**Subject: Cell 1 Construction Progress Report #3/CQA Plan  
Enterprise Recycling & Disposal Facility  
Angelo's Aggregate Materials, Ltd.  
FDEP Permit Nos. 177982-001-SC, 177982-002-SO  
Pasco County, Florida**

**Subject:** conversation with Jennifer Deal and Jim Golden about Enterprise CIII

**Subject: Additional Quality Assurance Testing  
Enterprise Recycling & Disposal Facility  
Angelo's Aggregate Materials, Ltd.  
FDEP Permit Nos. 177982-001-SC, 177982-002-SO  
Pasco County, Florida**

**FIGURE  
 1**

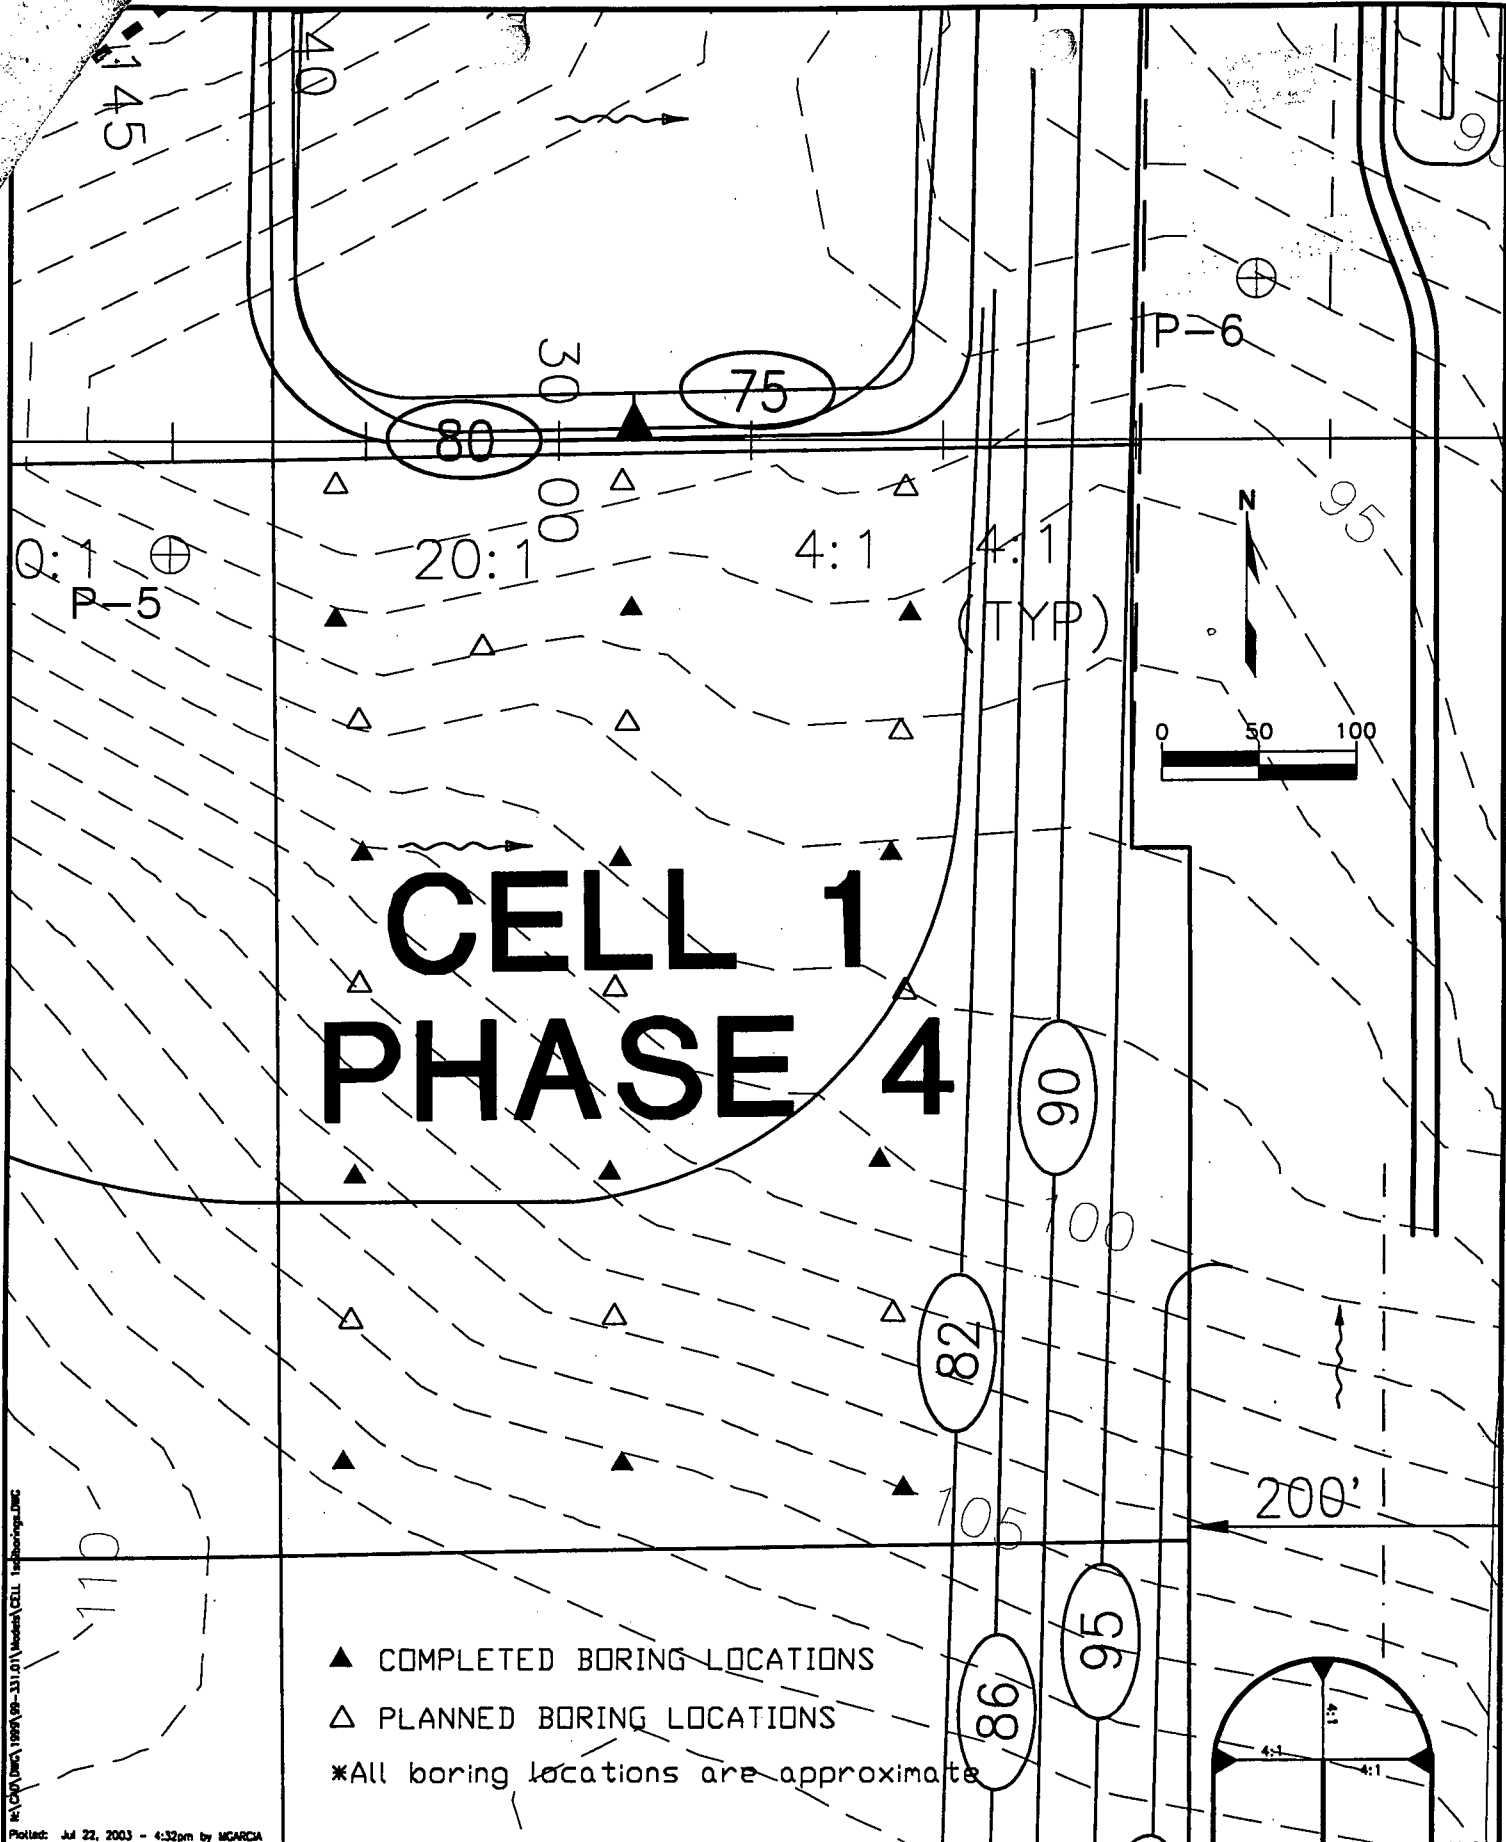
Thirteen auger borings will be completed in addition to the 12 samples already submitted to the laboratory for testing, for a total of 25 borings, or a grid of approximately 75-feet by 150-feet. This grid spacing will allow us to include the completed boring locations. From these additional borings, four additional permeability tests and thirteen additional sieve tests will be conducted. From these additional borings, four additional permeability tests and thirteen additional sieve tests will be conducted. Test results for the original 12 boring samples have not yet been received. If these results indicate the absence of a confining layer (low clay content) in any of those locations, additional deeper auger borings on a tighter grid will be performed in those areas until the confining layer is encountered and additional samples will be taken for sieve analyses. Please see the attached figure showing the boring locations. Although this additional testing is in exceedance of that required by the permit for the areas with consistent base soils, we will agree in order to expedite cell certification review.

Limestone was encountered in two of the first 12 borings. Test pits will be excavated in these locations using the heavy equipment on-site to determine the extent of limestone in these locations. Additional test pits will be excavated as necessary, based on the results of the additional borings.
